Addendum No. 3

Bid / Request for Proposal Call No. T2024-220 Construction of the Fire station

This Addendum forms part of the Bid/Proposal Document.
(Question 1-95 had already been replied in Addendum 01 and 02)

- 5. A04.02 – BUILDING SIGNAGE**
.i Delete issued for Tender drawing A04.02 in its entirety and substitute drawing A04.02 barring revision 4 appended to this document.

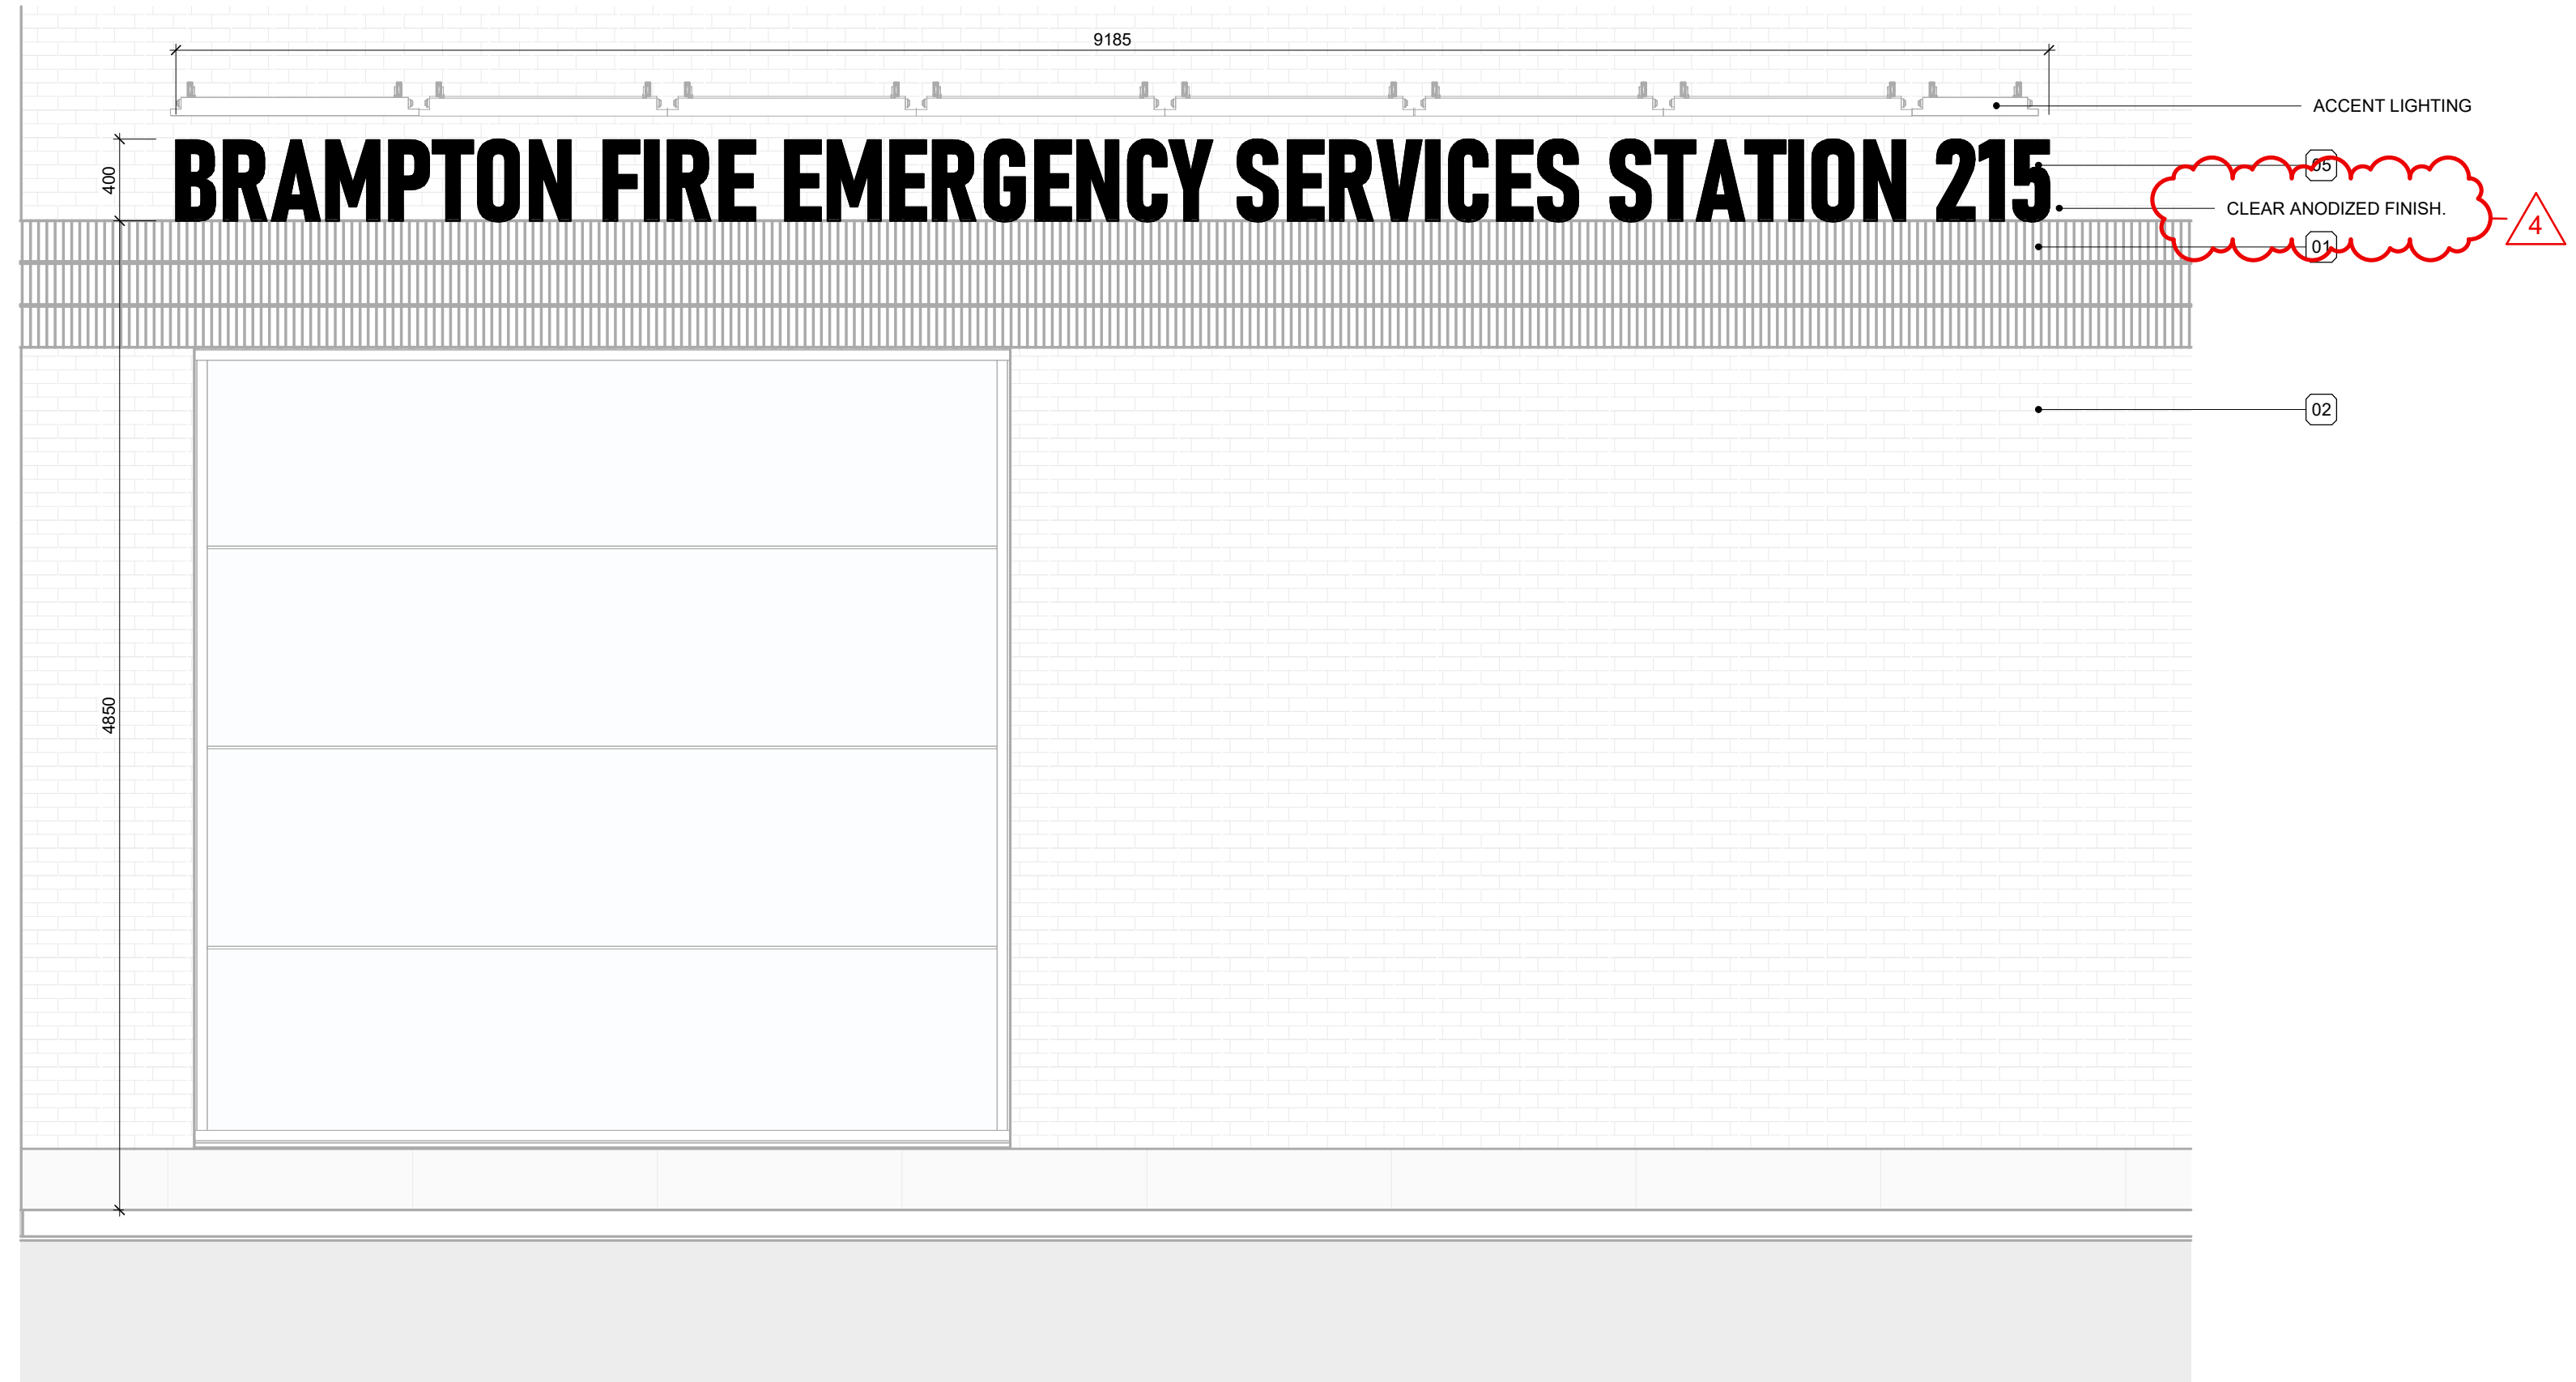
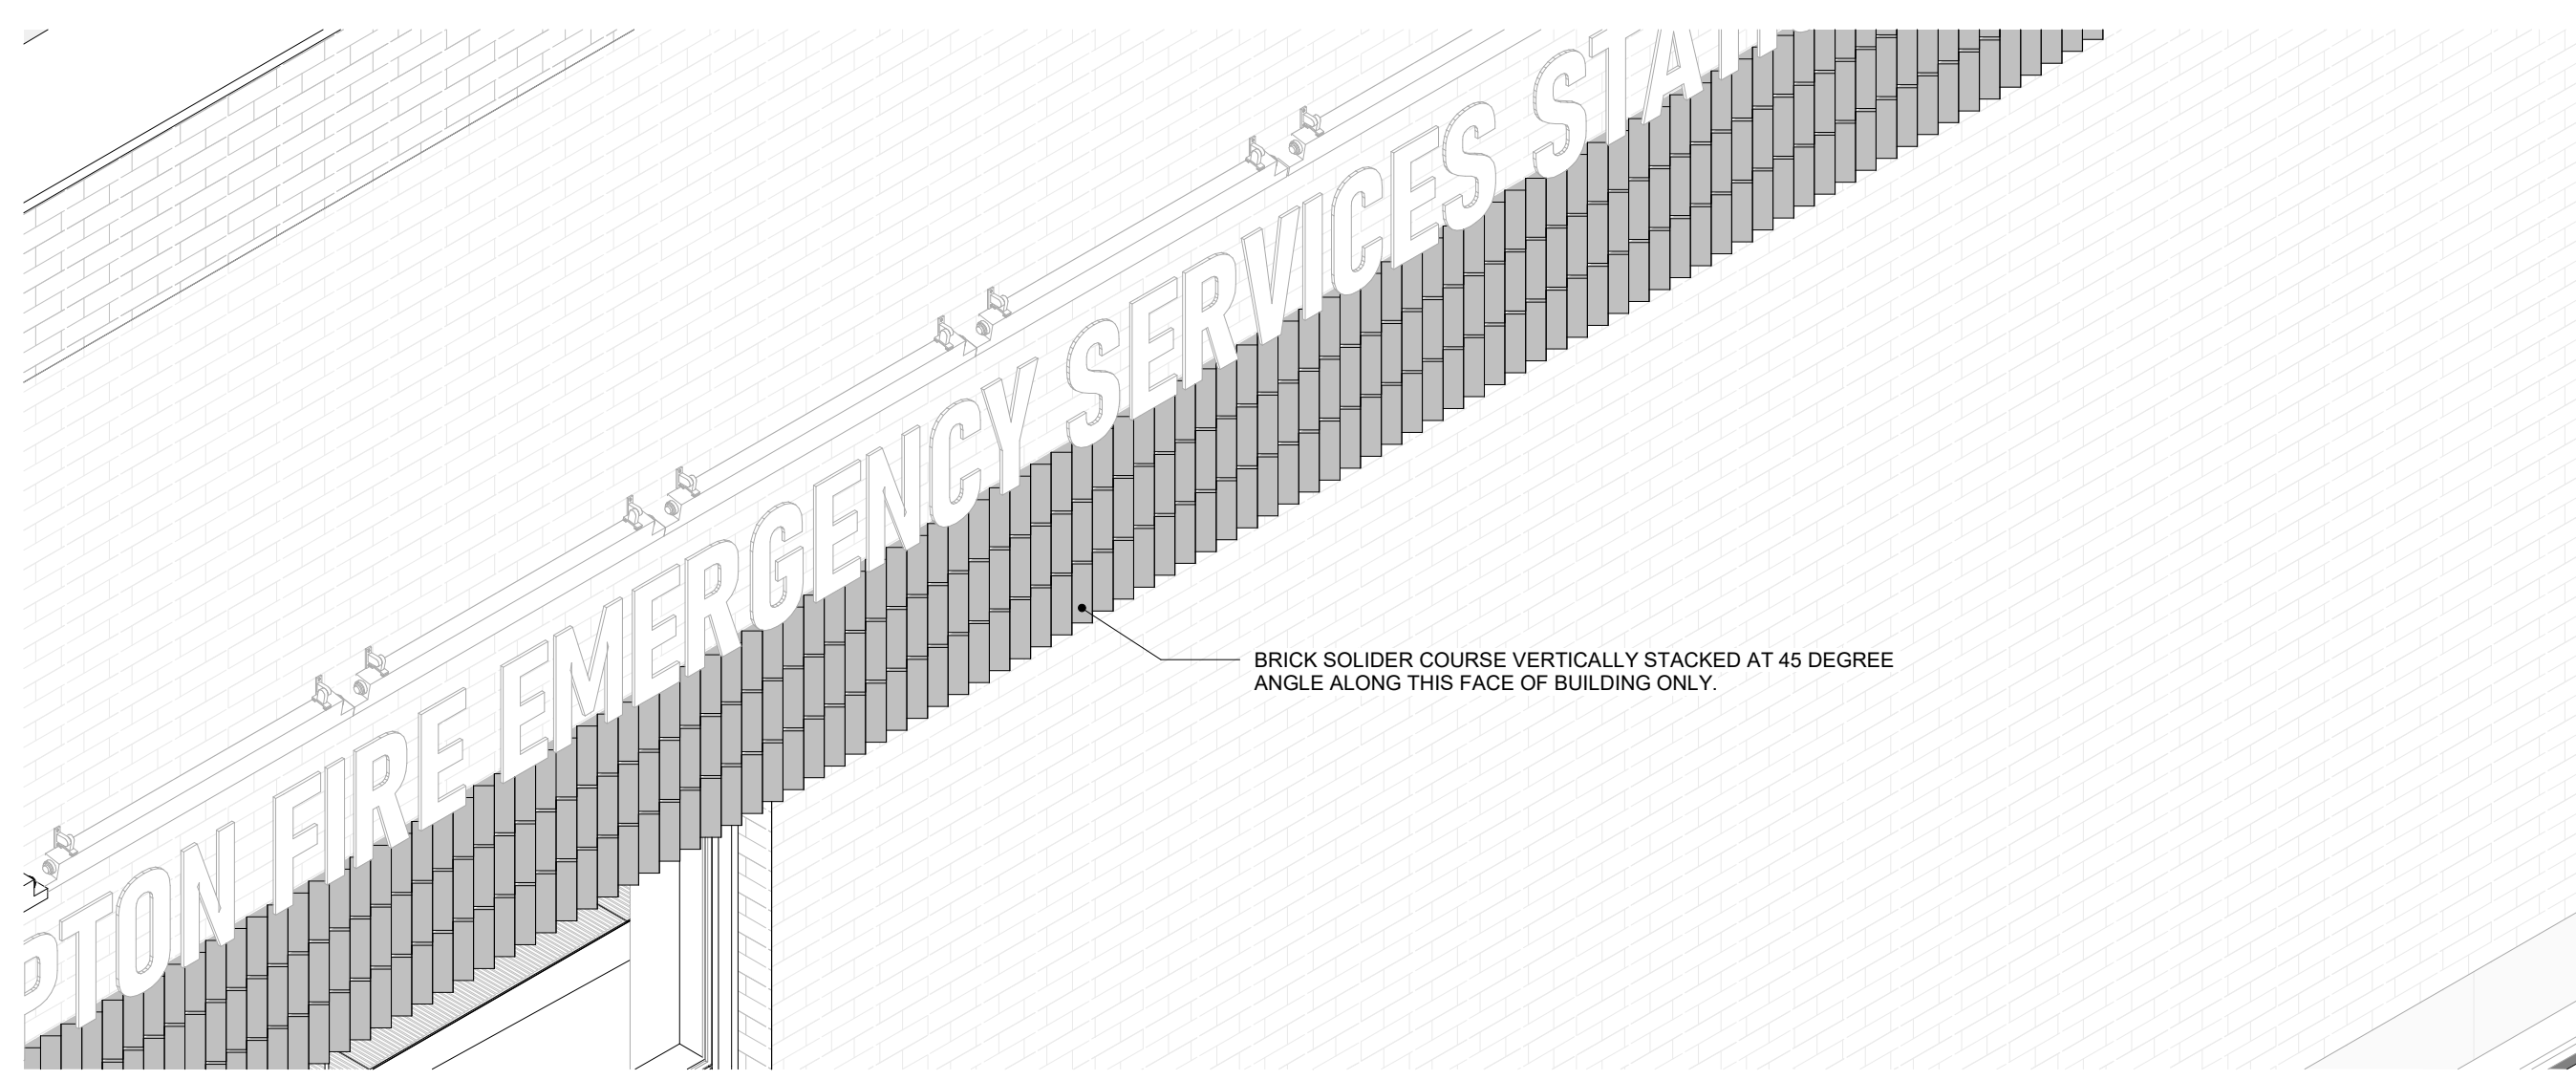
For Drawing no. A04.02, can we know what type of graphic for the crest does the architect look for ? (direct print Vinyl and attached to the base metal or engraved graphic?)

Refer to issued A04.02 – Building Signage drawing part of this addendum 3.
